Office Action Summary

10/580,205

HEID ET AL.

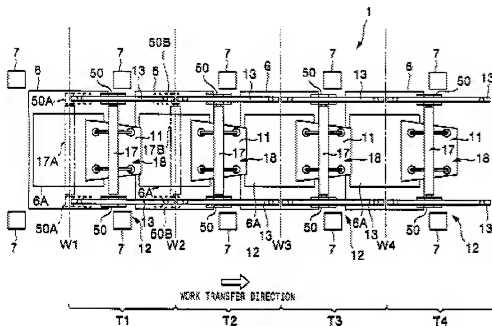
13. Limitations from claim 1, a conveyor for transporting work pieces in a press, in particular a multiple-die press (2), from a first station (W1) to a second station (W2) adjacent to the first station (W1), comprising a) at least one lateral beam (13) arranged on a side of the press, essentially extending parallel to a transport direction of the conveyor (1); b) at least one bar (17) having grippers (15—not shown in figure 1 above) for gripping the work piece to be transported, whereby the bar (17) is attached to the lateral beam (13) in such a way that it is movable along a longitudinal extension of the beam (13); and c) for each lateral beam (13) an assembly (7) for supporting the lateral beam (13) (pages 1-2, paragraph 13).

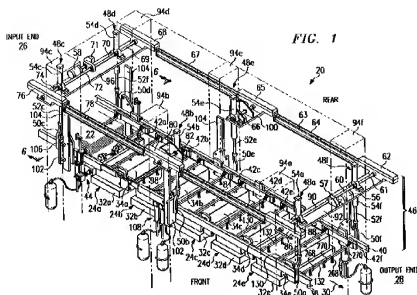
19. Limitations from claim 12, a conveyor system for transporting work pieces in a press line or multiple-die press, comprising a plurality of conveyors (W1-W4) according to claim 1, arranged consecutively (pages 1-2, paragraphs 13-14).

20. Limitations from claim 13, the conveyor system according to claim 12, characterized in that two consecutive conveyors (W1, W2) are arranged such that the work piece (11) may be handed over from a first of the conveyors (W1) to a second of the conveyors (W2), whereby the work piece (11) is flipped (pages 1-2, paragraphs 13-16).

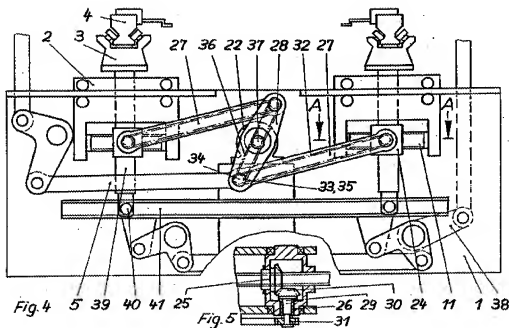
25. Limitations from claim 1, a conveyor characterized in that d) the assembly (20) comprises a pivoting mechanism (figure 5) (column 2, lines 42-54, column 3, lines 16-19, 28-34 and column 3, line 64-column 4, line 6).

26. Limitations from claim 2, the conveyor according to claim 1, characterized in that the pivoting mechanism (figure 5) is formed such that the pivotal axis crosses a vertical plane

comprising the lateral beam (38, 40), either through (384) the lateral beam (38, 40), in particular close to a middle portion of the lateral beam (38, 40) (column 3, line 64- column 4, line 6).
